Addendum #1

Pleasure Ridge Park

Issue Date: May 5, 2021

PLEASURE RIDGE PARK
FIRE STATION 1

M1.02R1

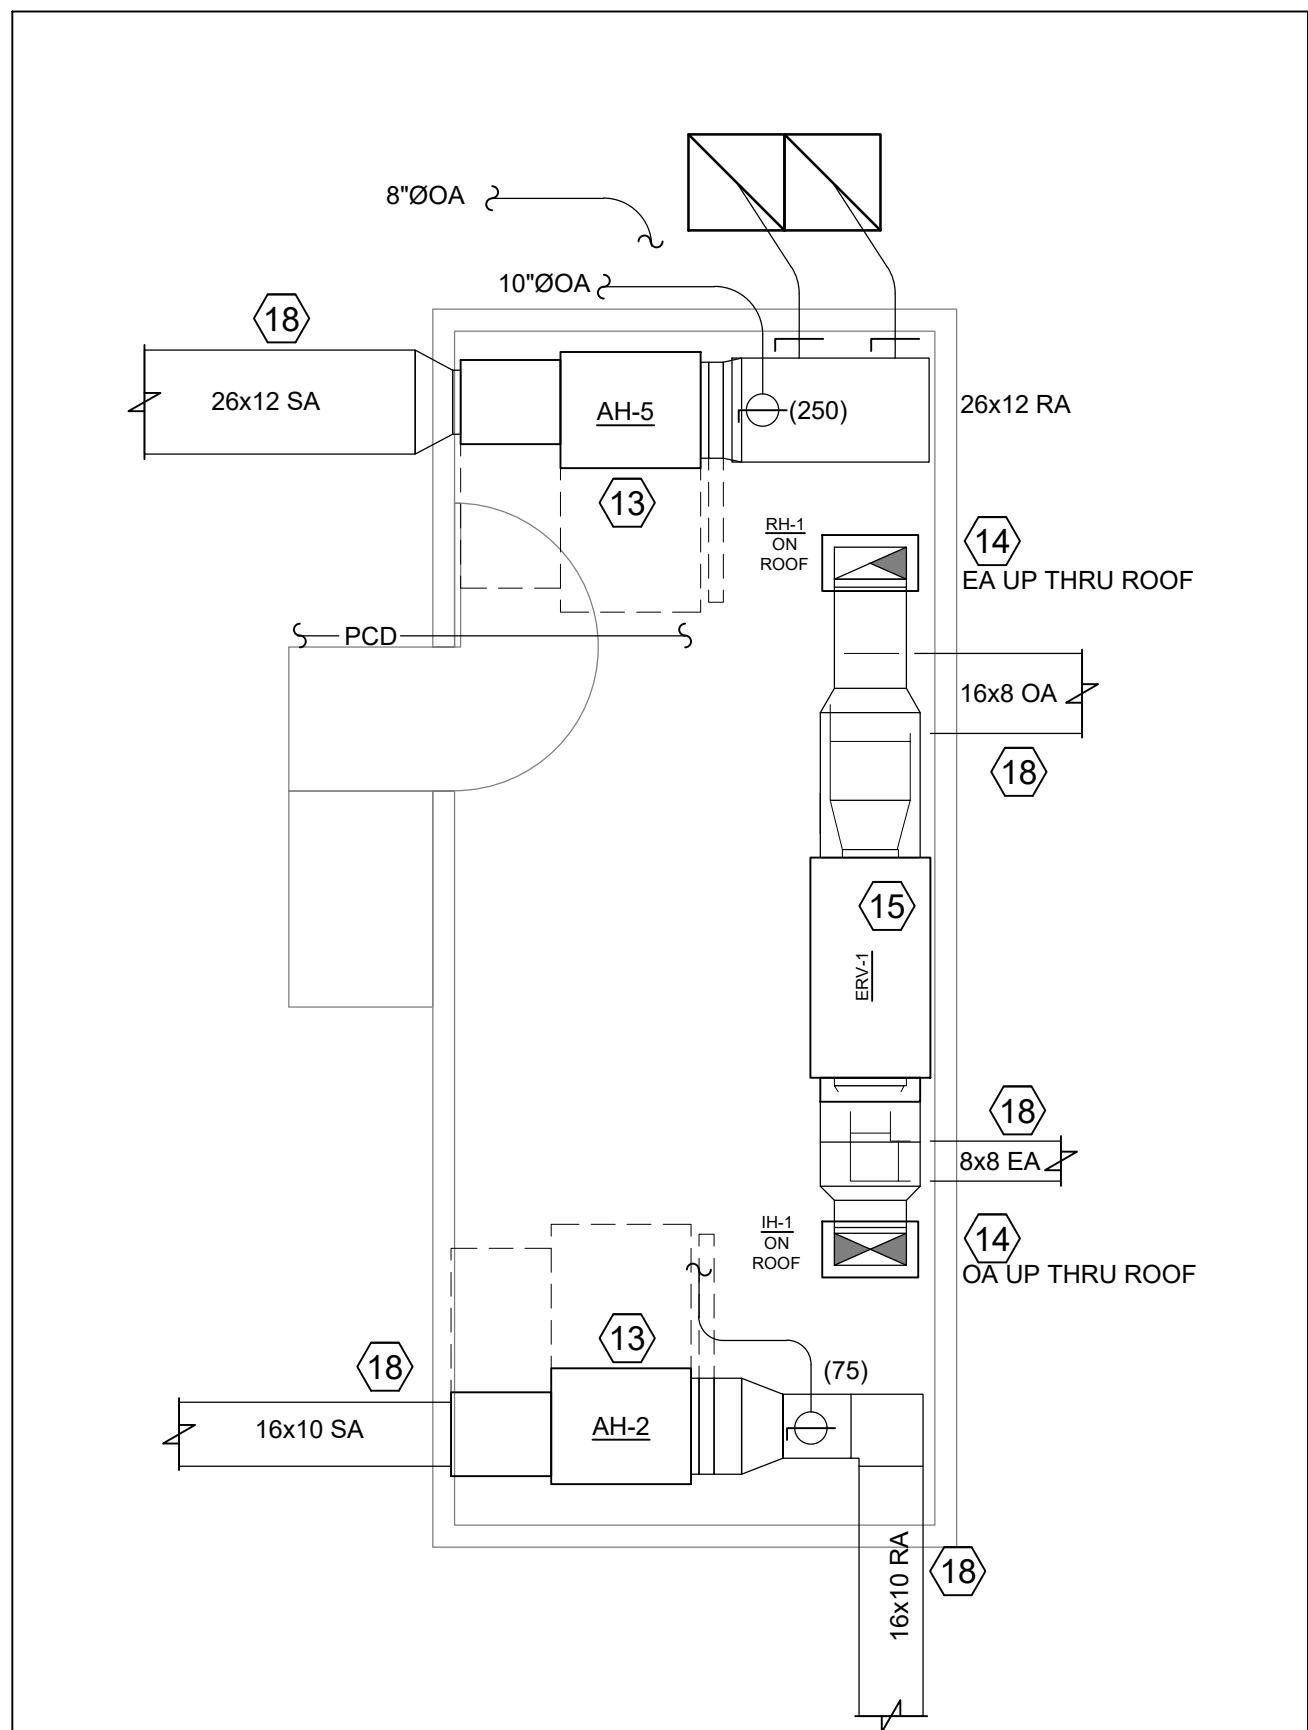
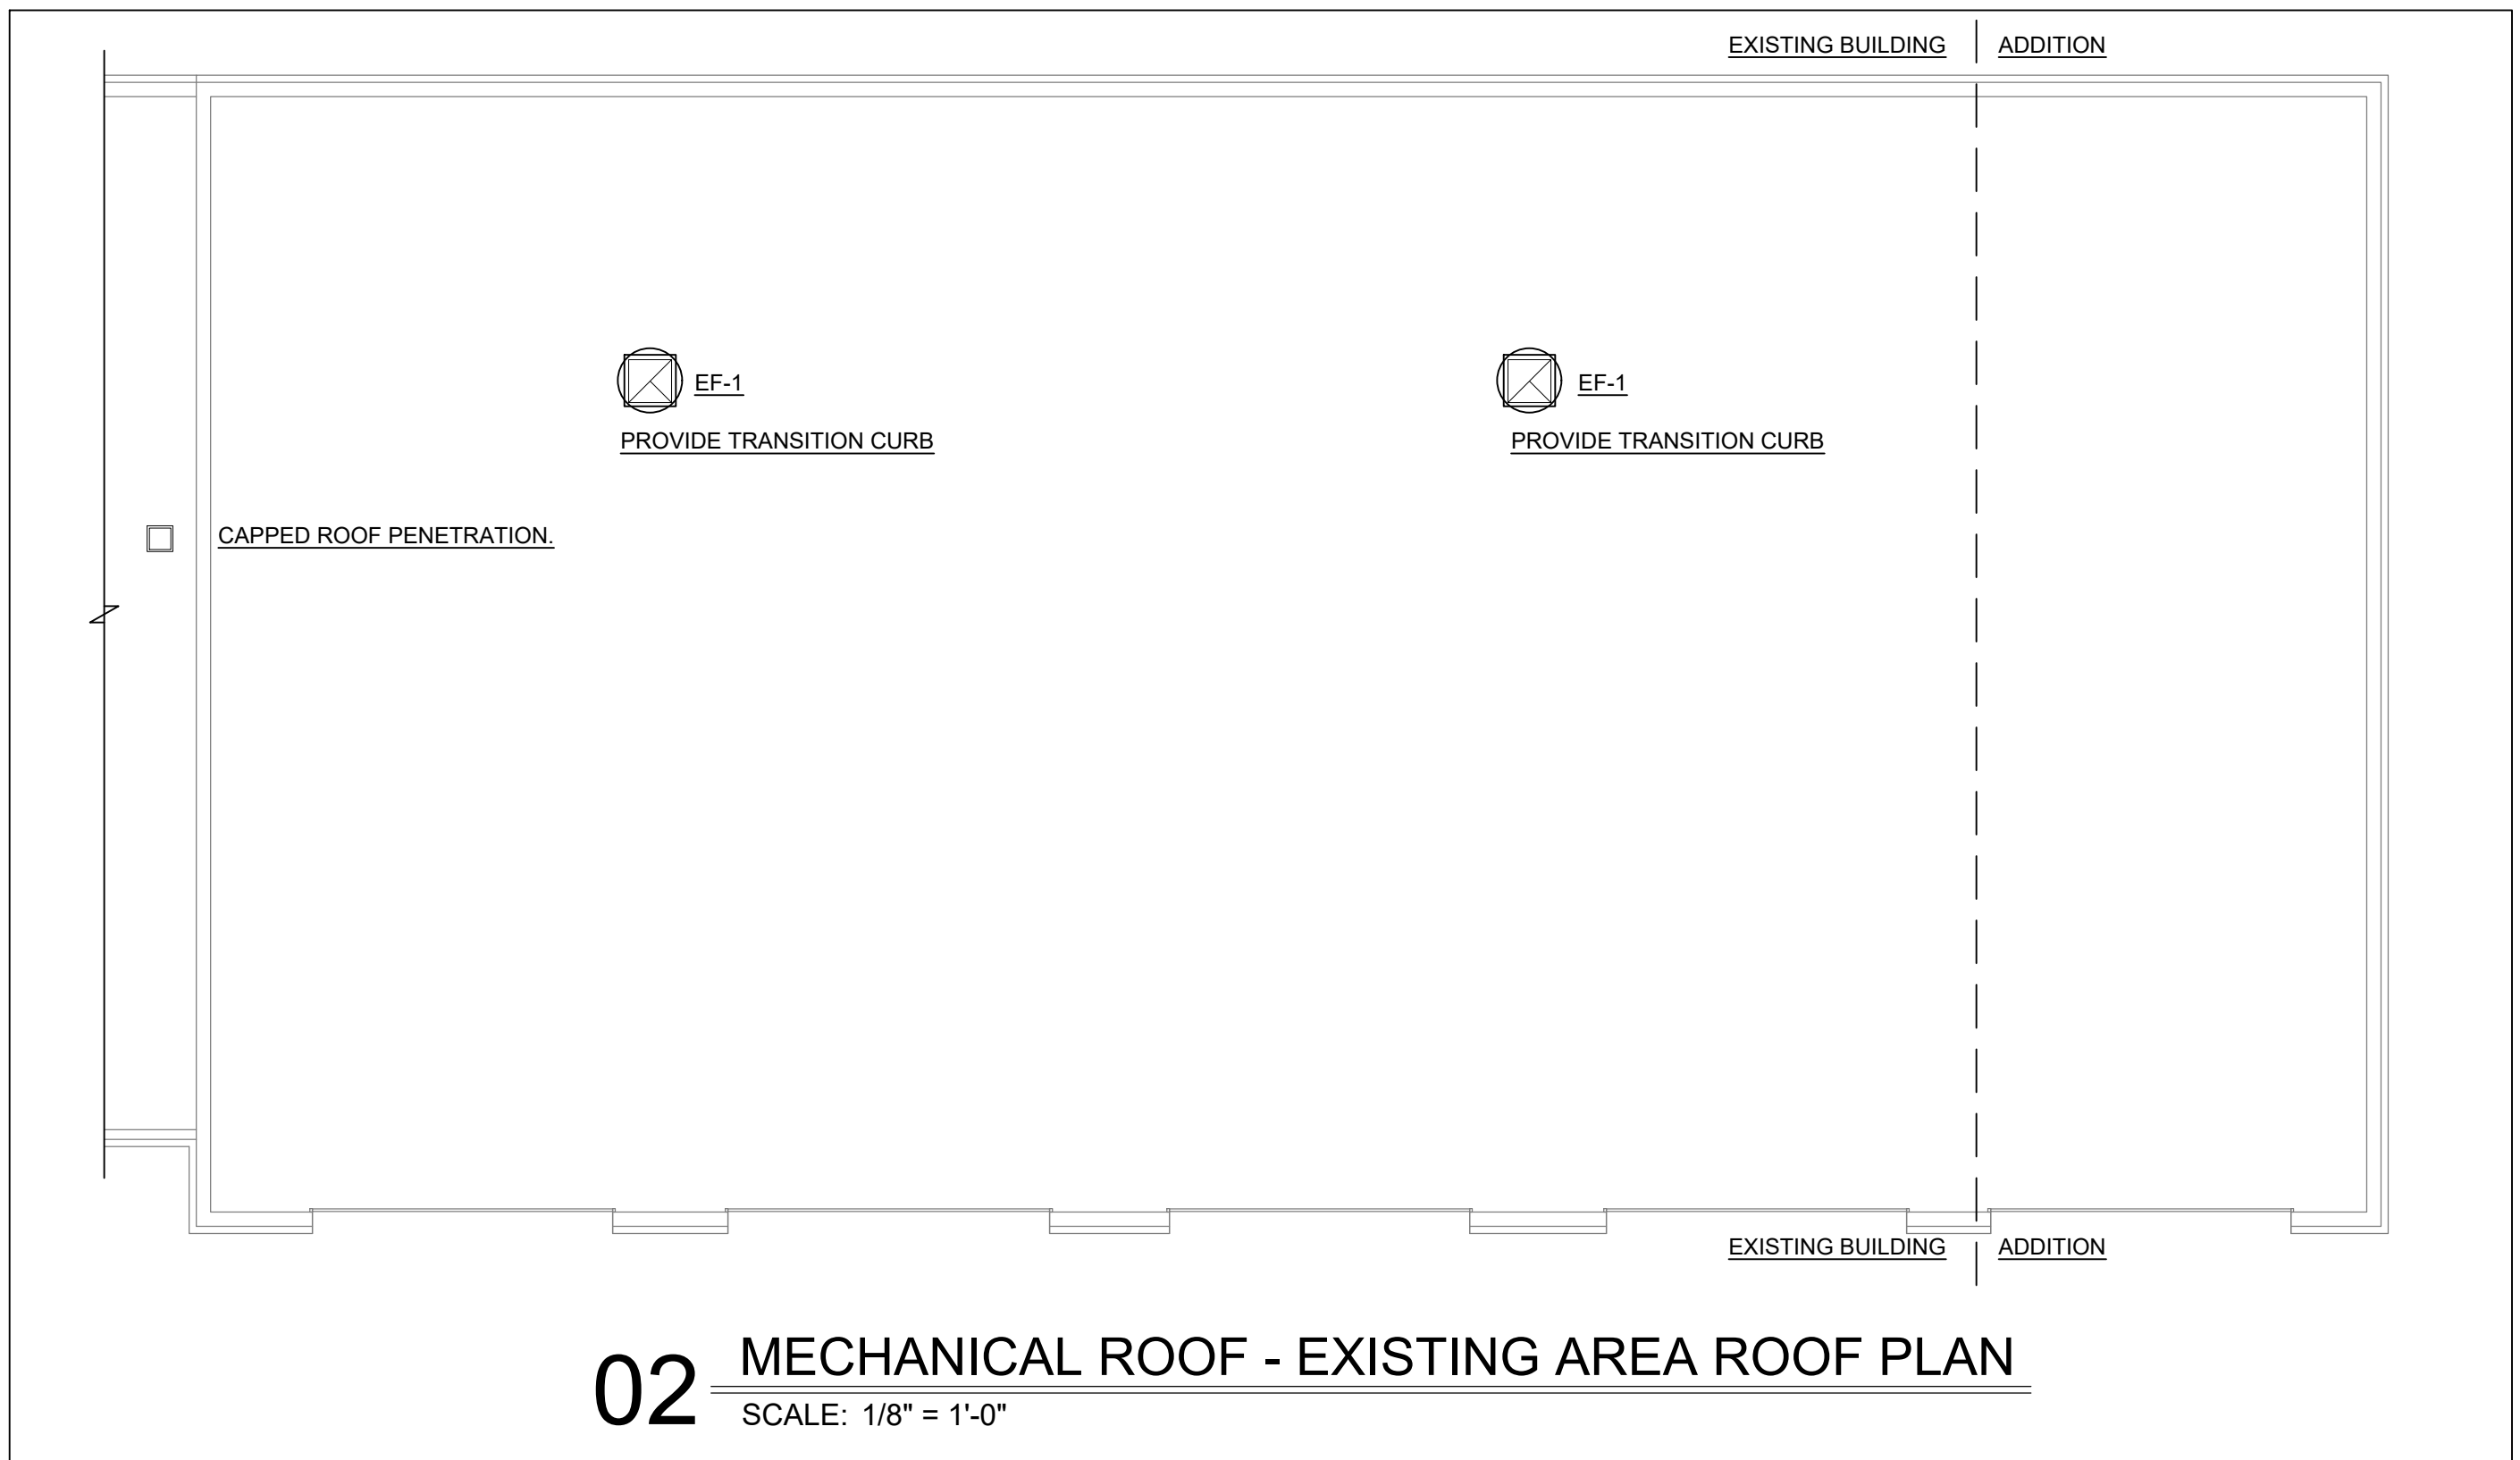
5. **03/A5.04** Joist size 8K 3@ 24 O.C.
6. Other manufacturers for the CO-RAY-VAC Infra –red system in new addition apparatus bay will be accepted if they meet the specifications and standards. **(Tagged notes/M1.02R1)**

7. Reference attached drawing **M1.02R1** for revised ceiling callouts.
8. See revised sheet **M1.03R1** for revised condensate piping routes for VR System.

1. INSTALL NEW INDEPENDENT CO-RAY-VAC INFRA-RED SYSTEM IN NEW ADDITION APPARATUS BAY. INSTALL MODULATING GAS BURNER AND REFLECTOR JUST UNDER THE OVERHEAD DOOR IN ITS RAISED POSITION. PROVIDE WITH HIGH-EFFICIENCY HEAT REFLECTOR TILTED 45° TOWARDS OPPOSITE END OF BAY. TUBE SHALL BE OF ALUMINIZED STEEL WITH STAINLESS STEEL COUPLINGS. PROVIDE INSULATED VENT TERMINATION AND CAP RATED FOR GAS FIRED APPLIANCES.
